FINAL  
ENVIRONMENTAL IMPACT STATEMENT

F-15E BEDDOWN AT SEYMOUR JOHNSON AFB,  
NORTH CAROLINA

November 18, 1988

FIGURE 3-2-3  
BASELINE NOISE MAP-BASE

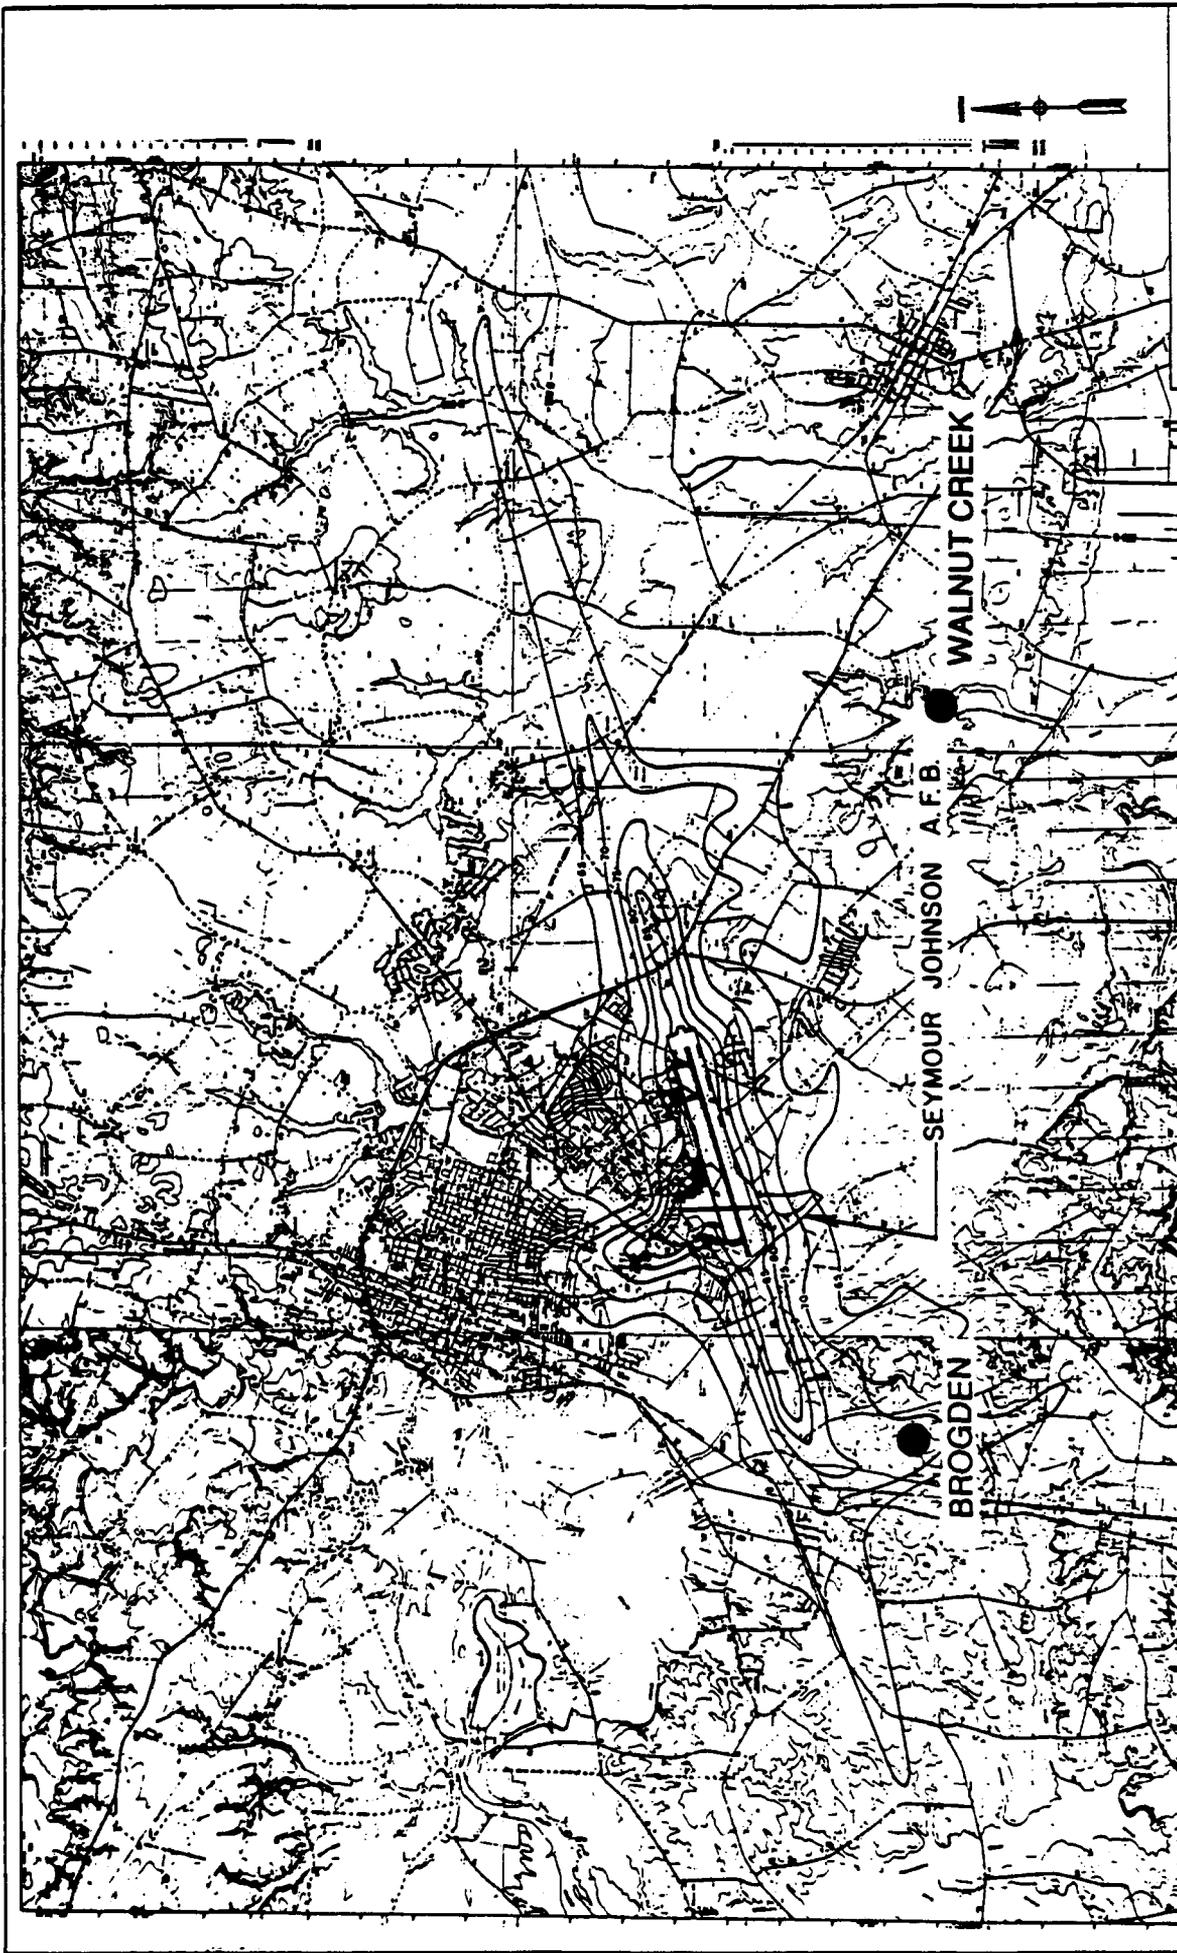
7. In line with comment 4, Figure 3.2-2 only provides a benchmark for showing the noise contours during the 1983 time period. To gauge the short term impacts, the reader should compare Figures 3.2-3 and 4.2-1 which are comparably scaled. Brogden and Walnut Creek have been identified on the maps which are provided in the errata section of this document. Tables 4.7-3 and 4.7-4 both represent "worst case"; the change in the noise level column represents the difference between a value of 55 DNL or the comparable compatible use district (CUD) from Figure 3.2-3. (if the area in question is within the AICUZ), respectively.

15. p. 3.2-5, Figure 3.2-3: See revised Figure in this section.
16. p. 3.2-14, Table 3.2-2: See revised Table in this section.
17. p. 3.3-7, 1st paragraph of section 3.3.5: Delete "or around." Add following sentence: Cliffs of the Neuse State Park does provide some unique geological features.

FIGURE 4.2-1  
 PROPOSED ACTION  
 NOISE MAP-BASE

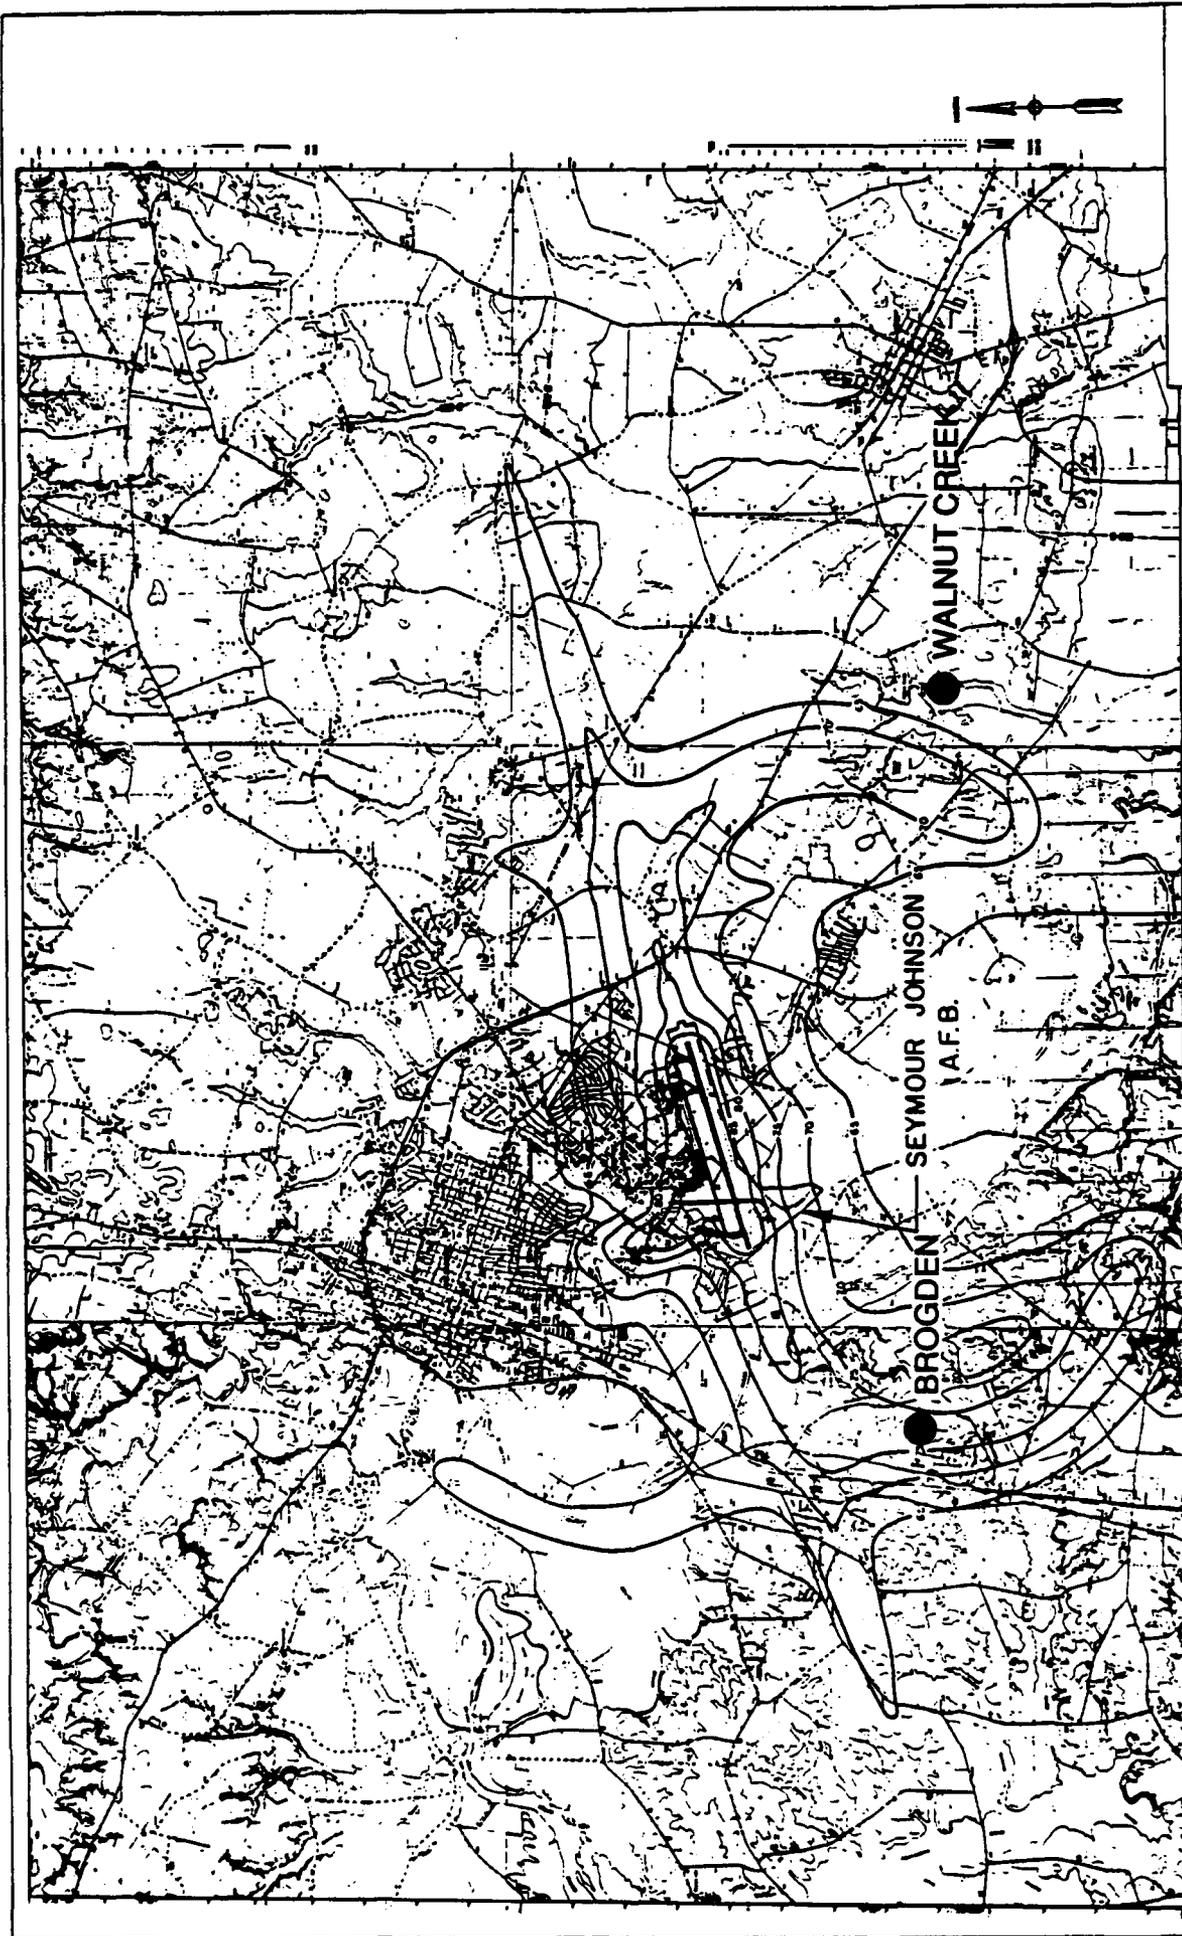
6. We believe the comment refers to Figure 4.7-4; however, reference to background noise levels is done deductively by referencing Section 3.7.1.3 of the DEIS. Consequently, the Brogden and Walnut Creek areas are taken to have a 55 DNL noise level. Although we believe this is conservative, no noise surveys have been conducted.

18. p. 3.4-12, 3rd paragraph, last line: Change Figure 3.0-1 to 3.0-2.
19. p. 4.2-2, Figure 4.2-1: See revised Figure in this section.
20. p. 4.2-4, 2nd paragraph, 3rd line: Change 38 to 14.

● Approximate locations of "worst case" increases in sound level due to the proposed action.

Figure B-9 VR-1043

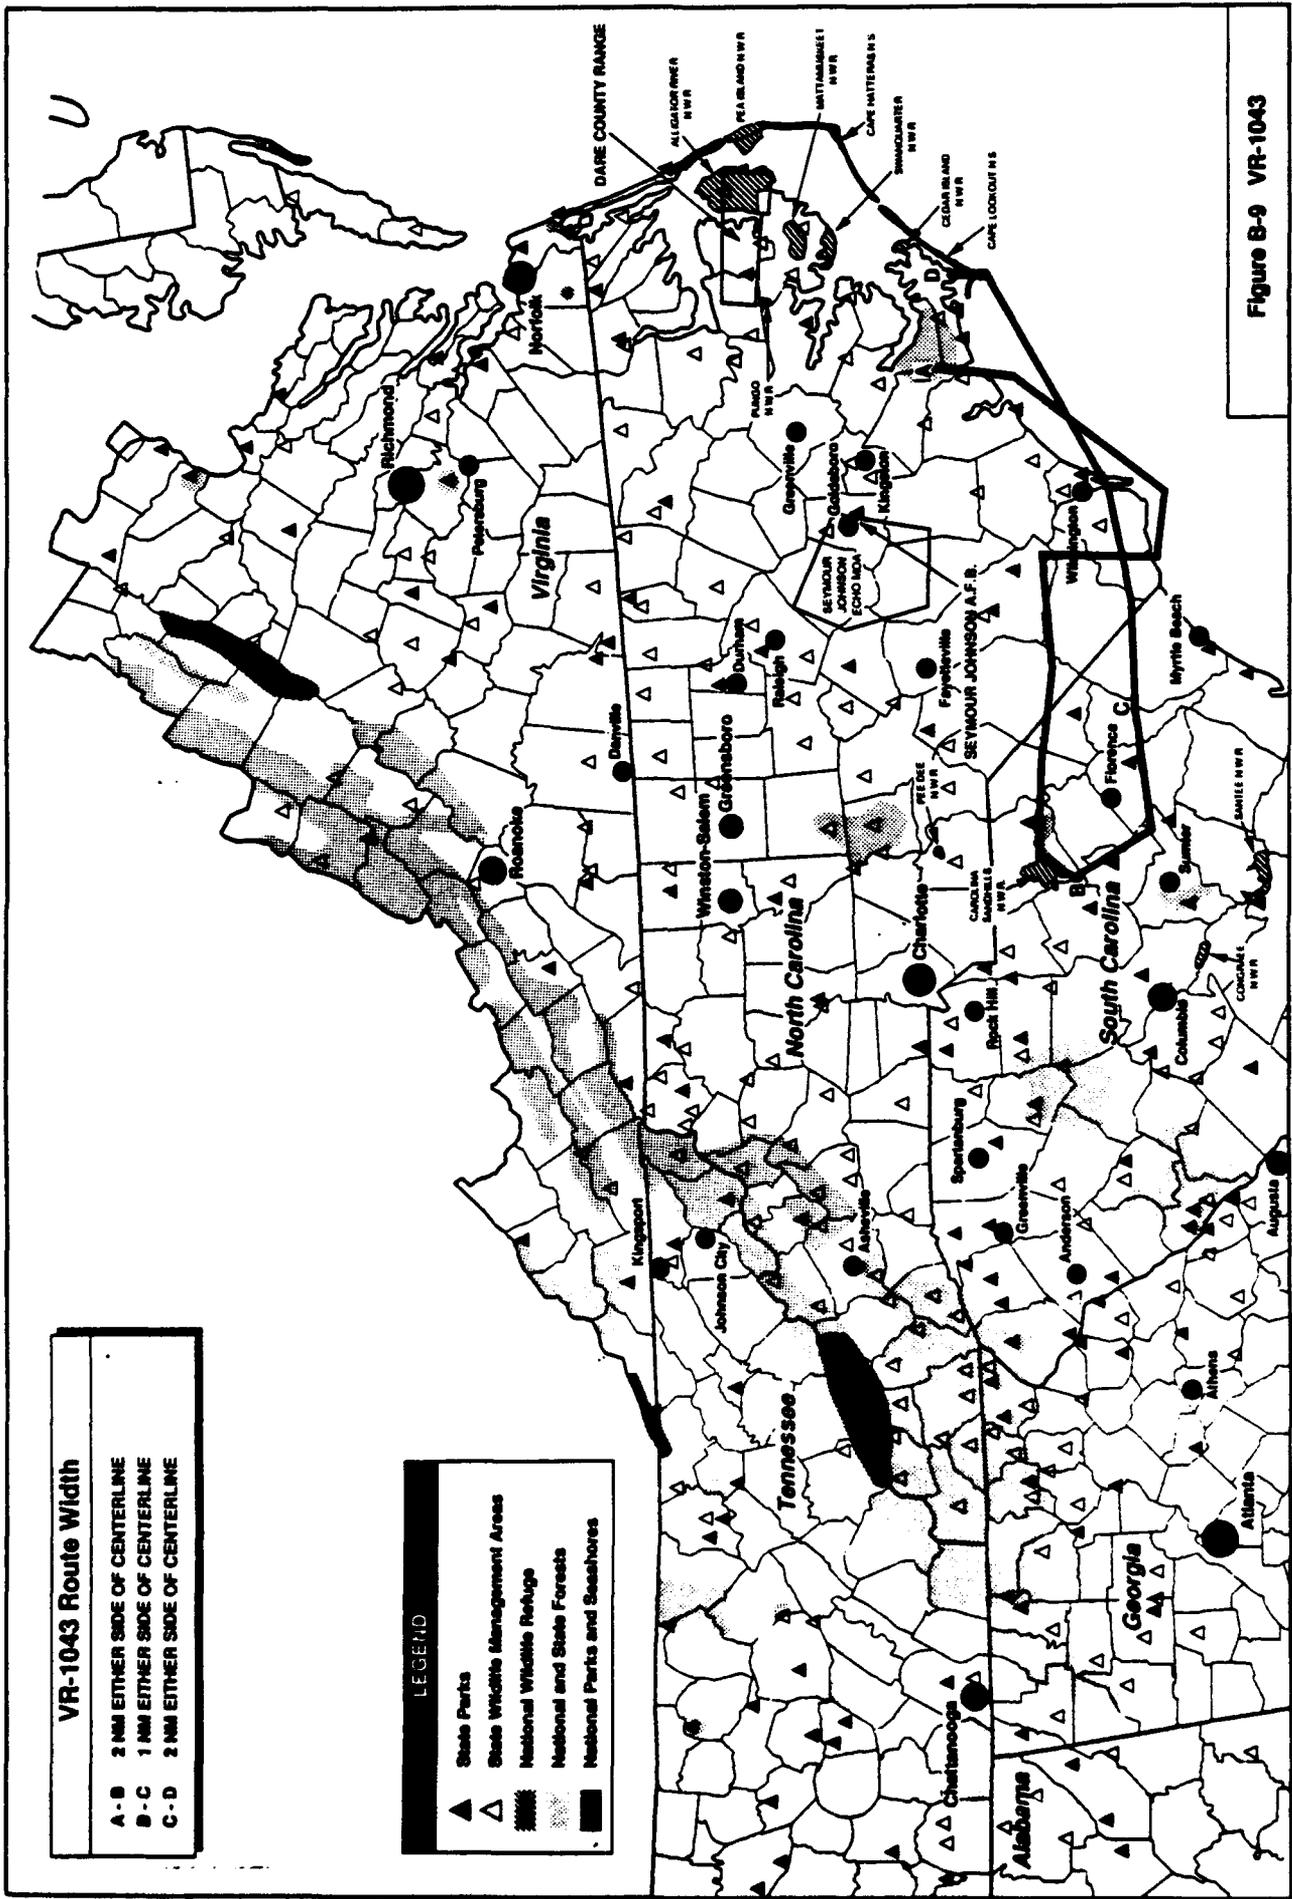
13. p. 2.4-2, Table 2.4-1, Impact Area, No Action Alternative, and Proposed Action columns: Insert "Fire Potential", 0, and 0, respectively.
14. p. 3.0-3, Figure 3.0-2, VR-096 and VR-1043. Routes were drawn beyond legs specified in AP1B extracts for MTRs. See revised maps in Appendix B.
